ST.MICHAEL'S Manchester
Supplementary Design Report

July 2023

This report is intended to illustrate the differences between the consented development scheme and the latest proposed design iteration. The proposed design incorporates changes concerning the refinement and evolution of the consented design in response to concerns of environmental, practical, and cultural changes that have occurred through the course of the project.

Ground Level

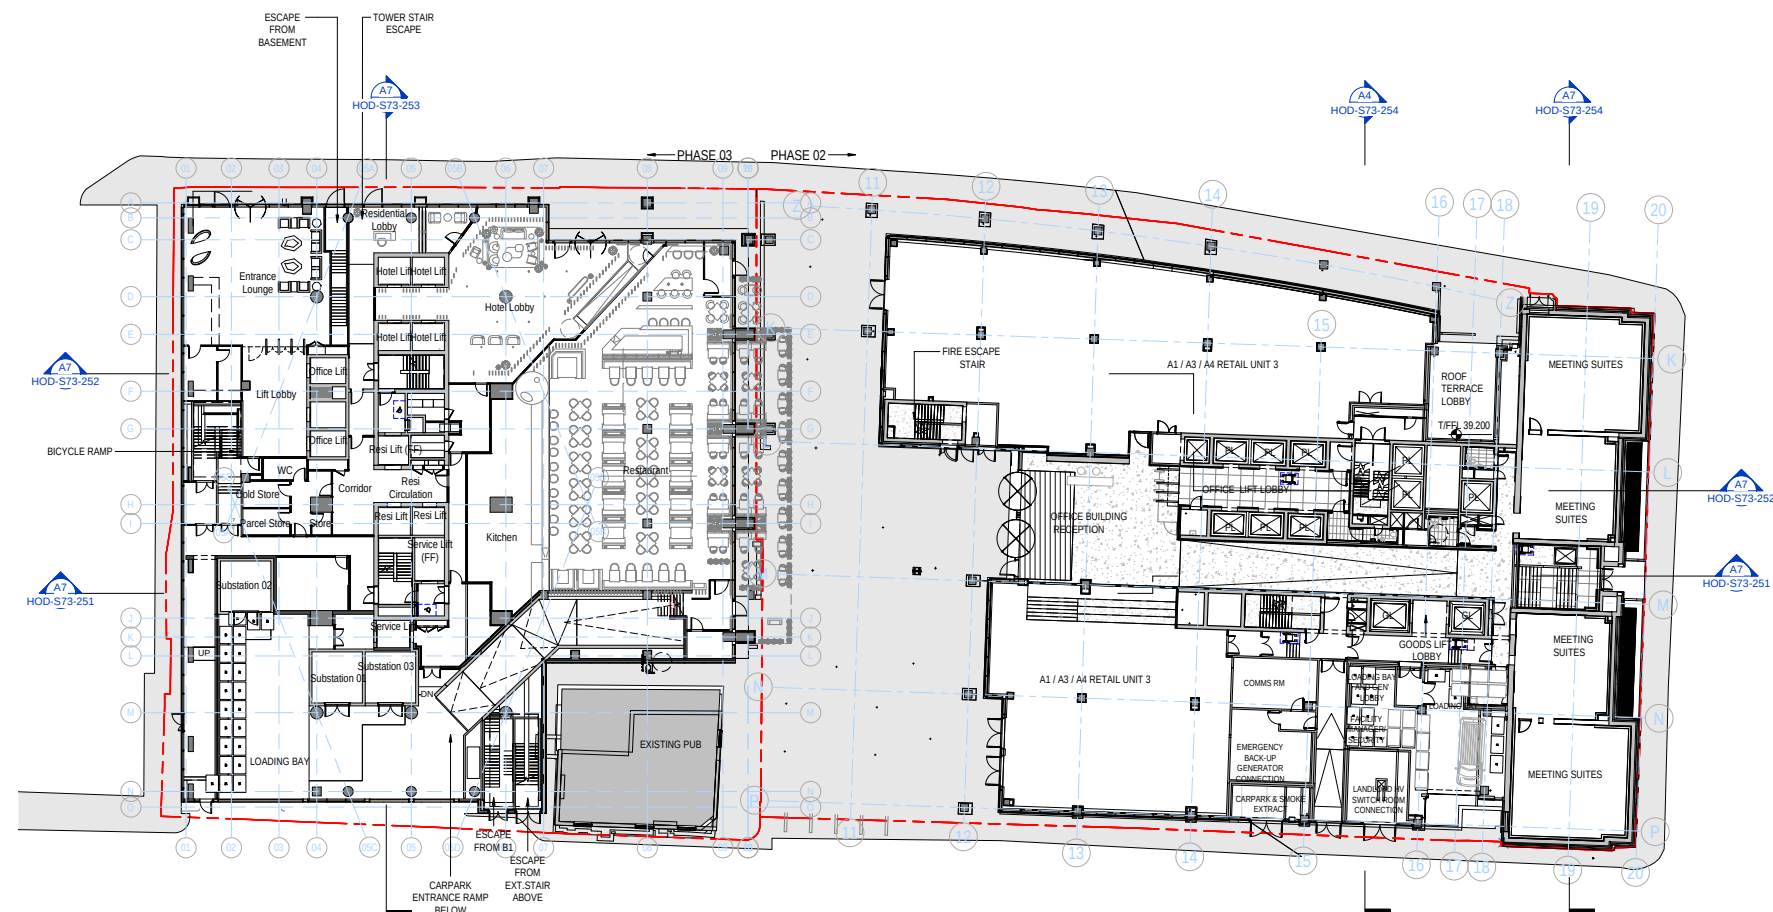
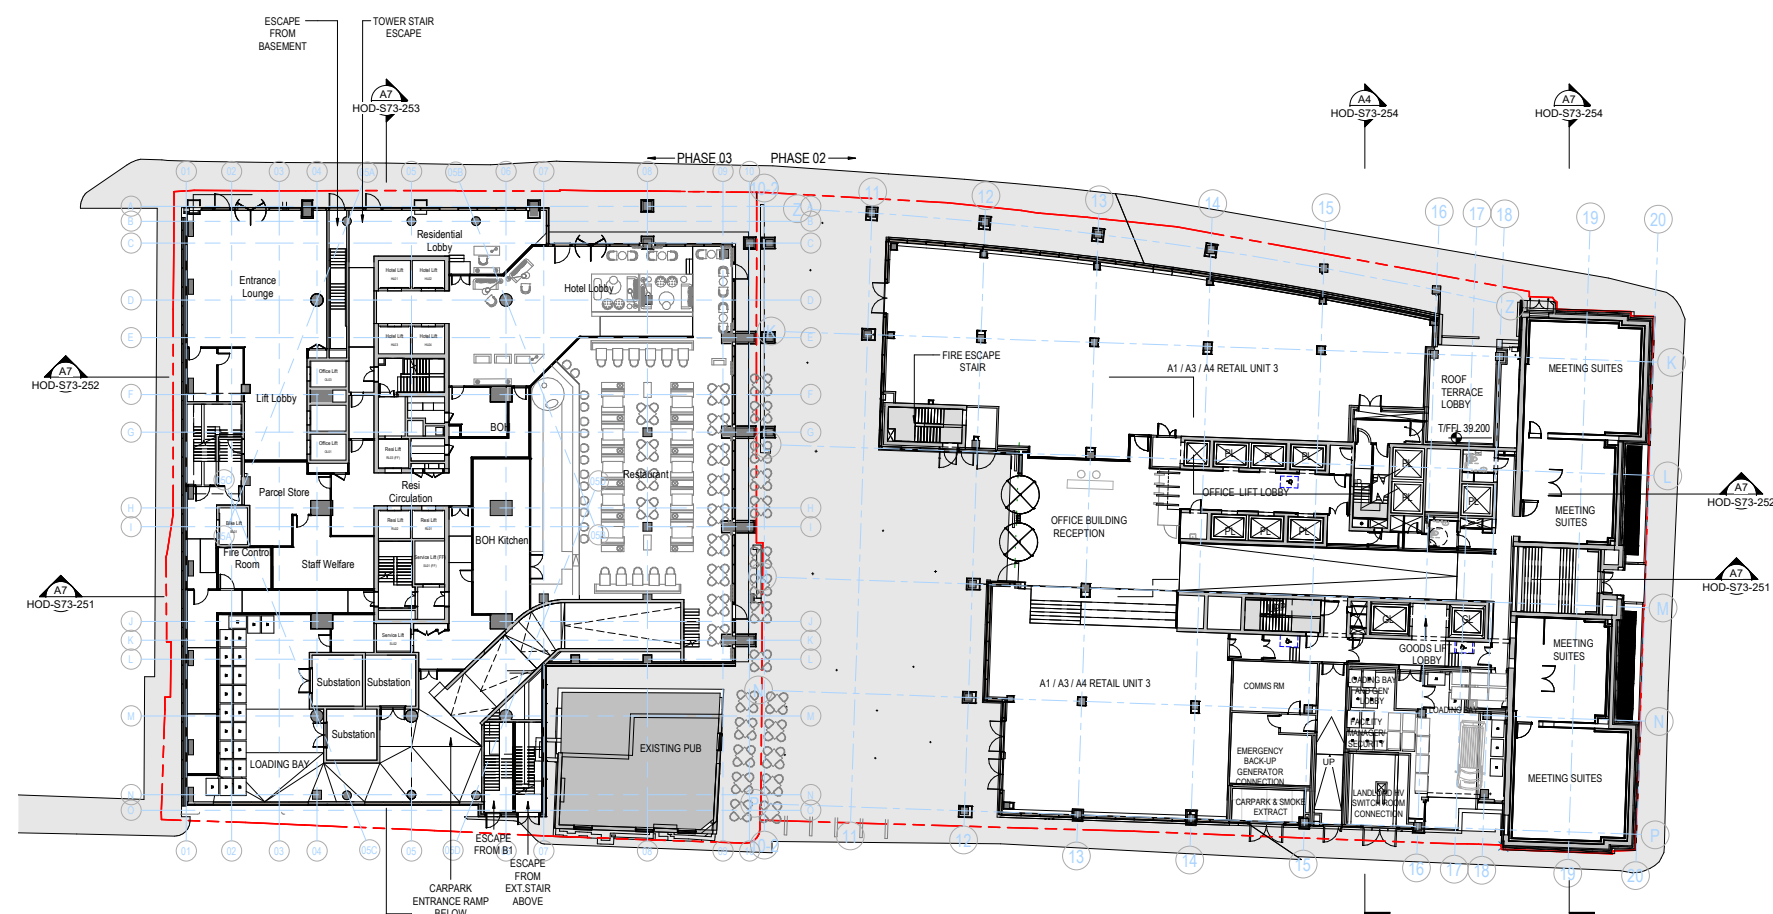
The Ground Floor has been reconfigured to allow for the changes in cycle provision. Cyclists can access the cycle stores via dedicated entrances with wider corridors for ease. In Block A, the cycle lift has been omitted and stores will now be accessed from Bootle Street via a bicycle stair ramp located in Stair 03. Disabled and scooter access to the stores will be made separately, via lifts as outlined in the Building Management Plan. For Block B, access remains the same with the cycle store accessed via the service lift from Bootle Street.

There has been further amendment of the internal layout as part of detailed design development with the client.

Level 06

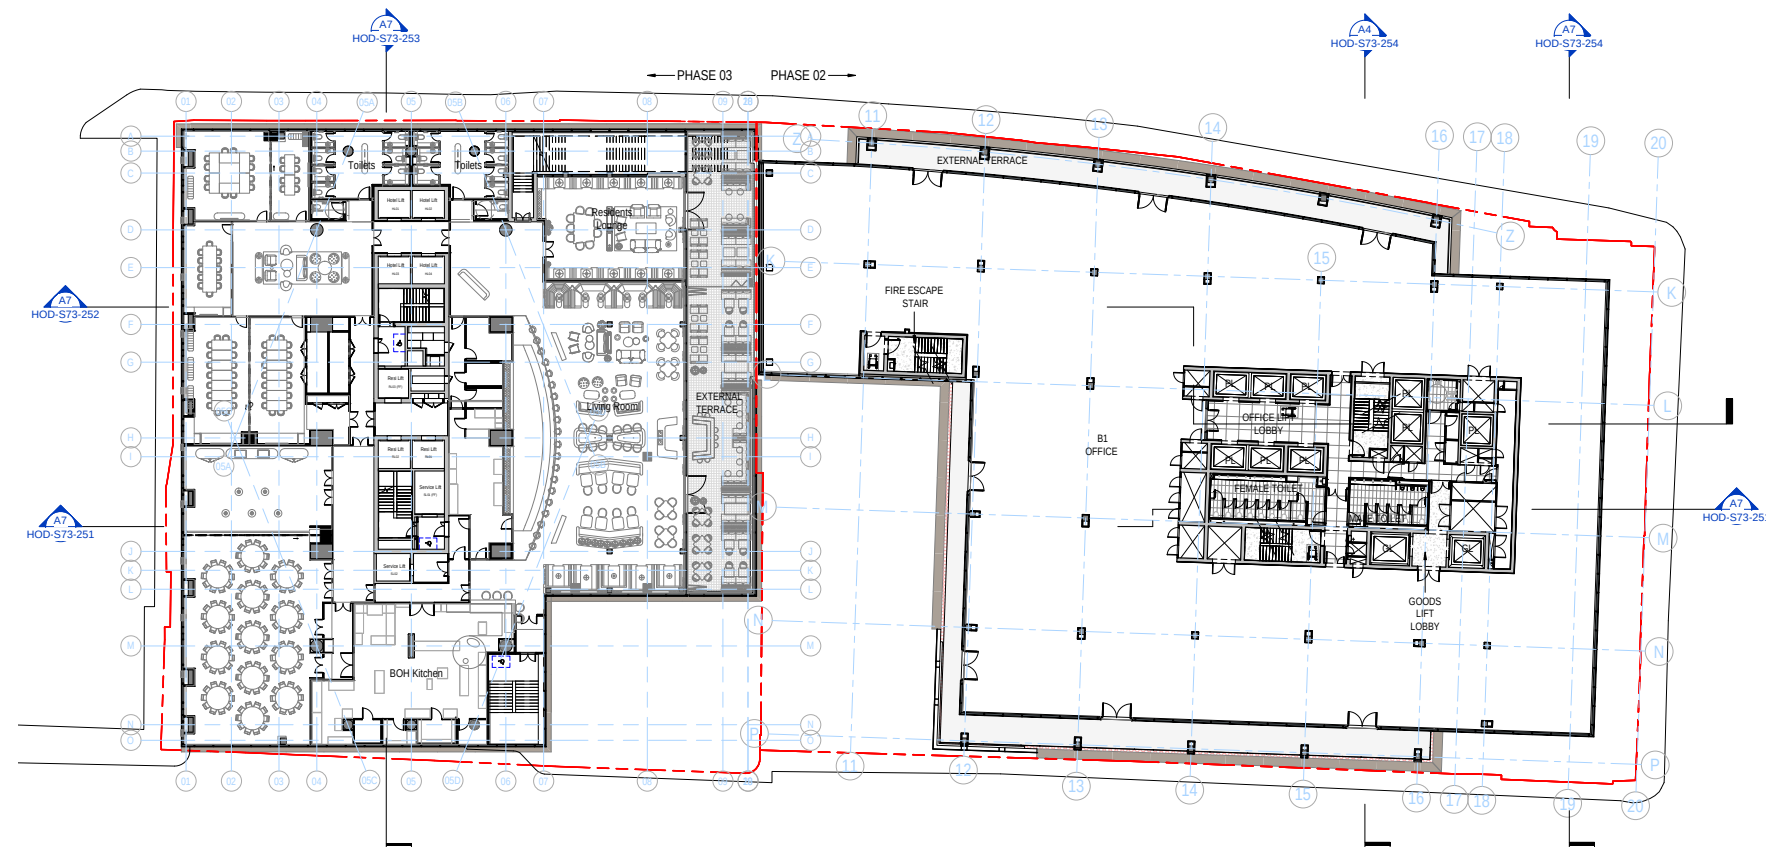
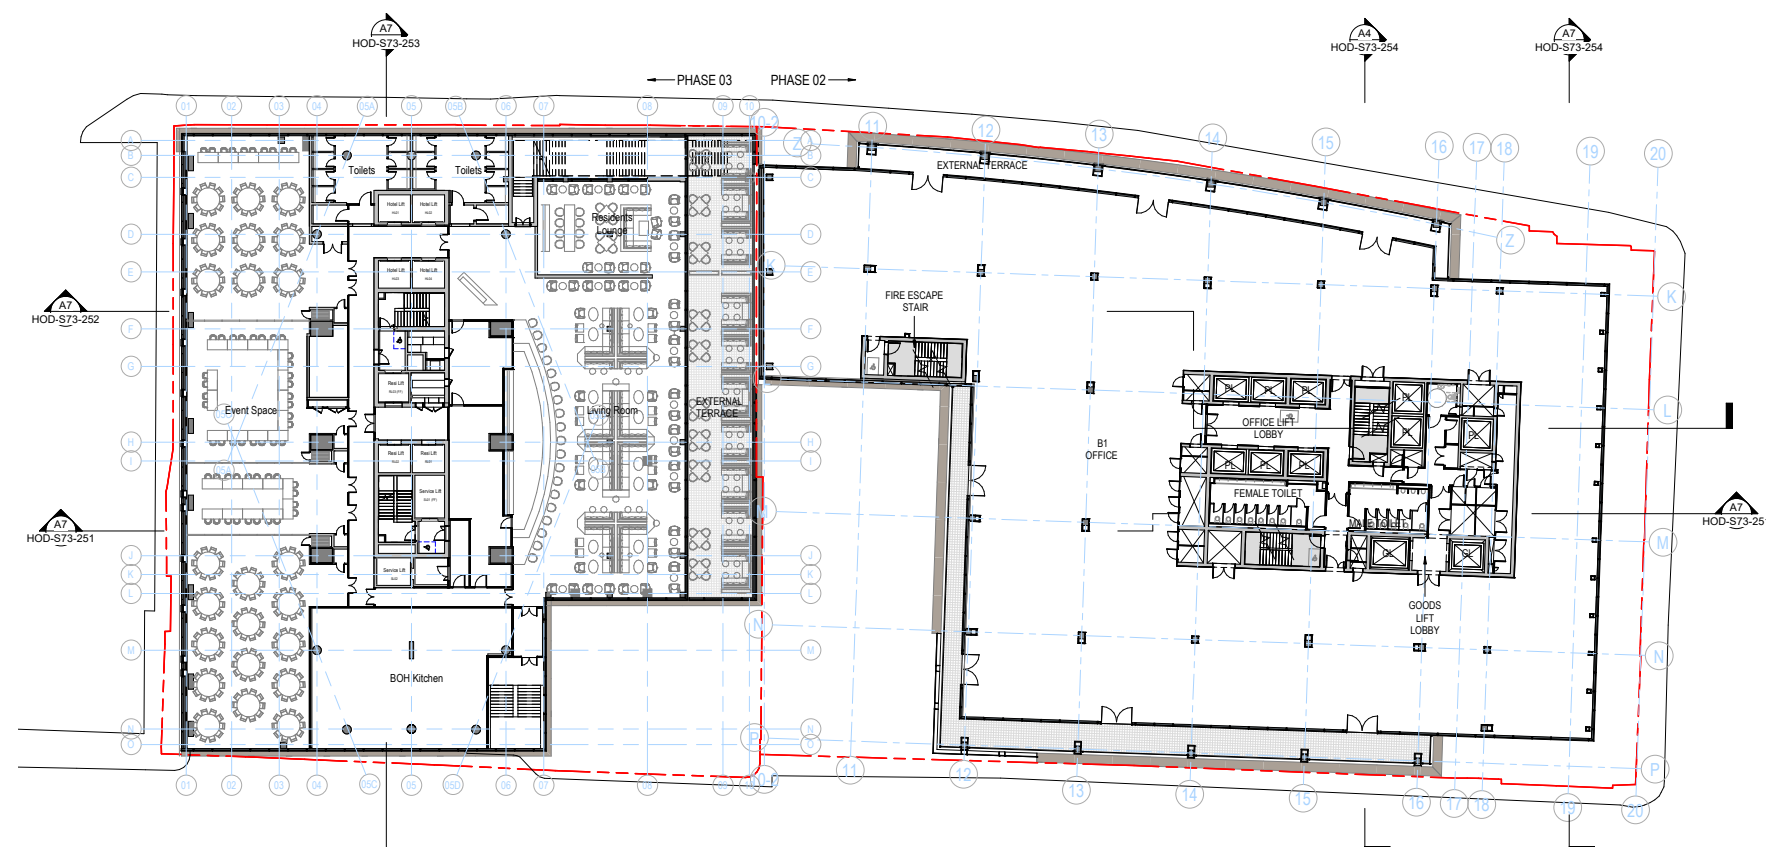
The interior layout has been amended as part of detailed design development with the client.

Level 07

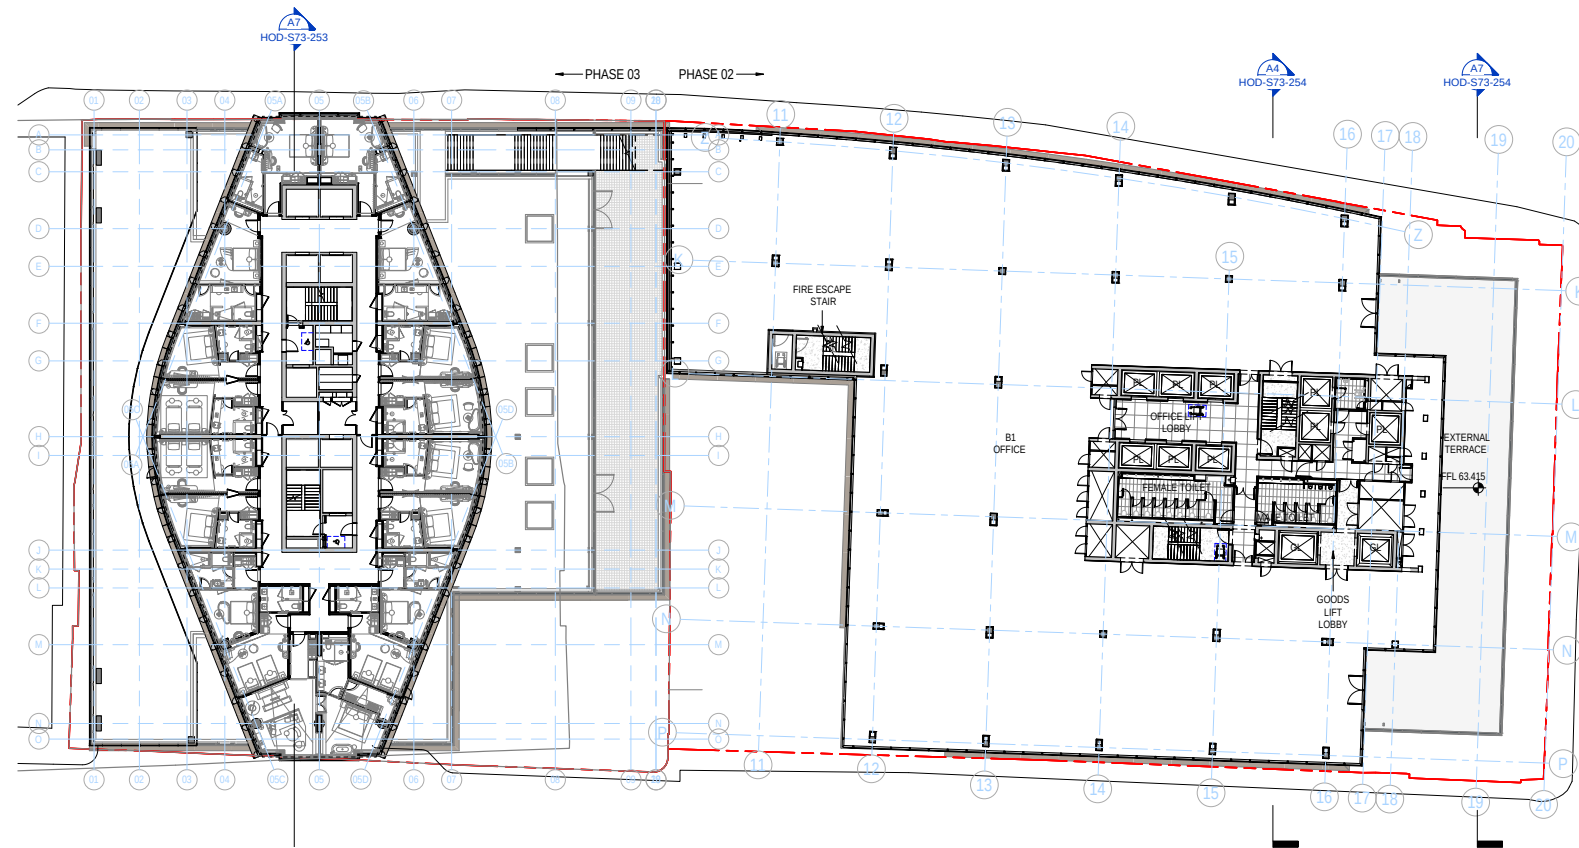
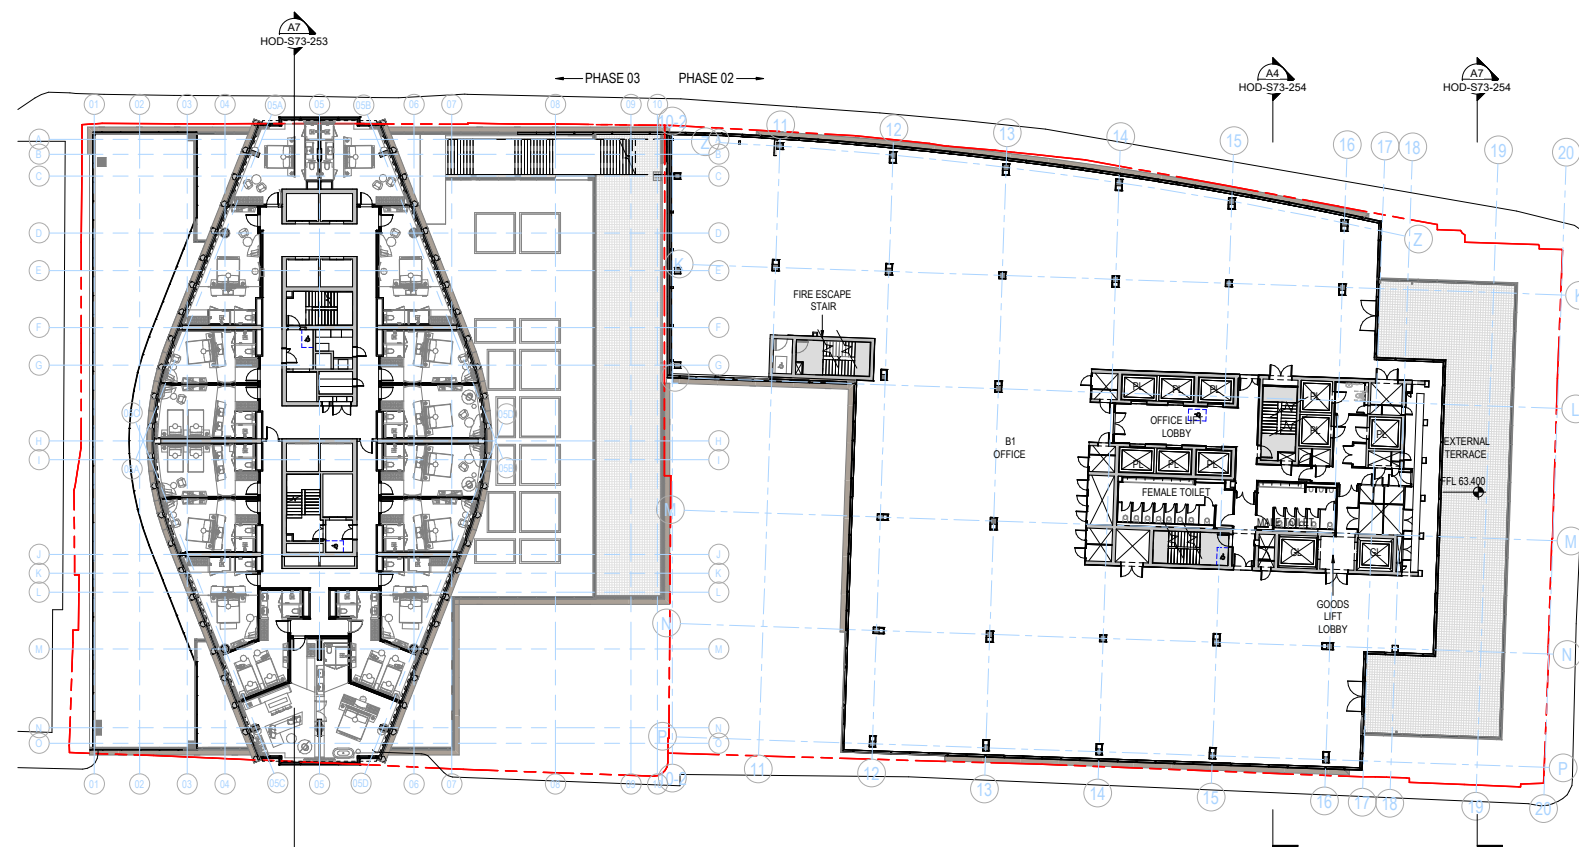
The number of rooflights on Level 07 has reduced to keep a clear landing zone for Building Maintenance Units (BMUs).
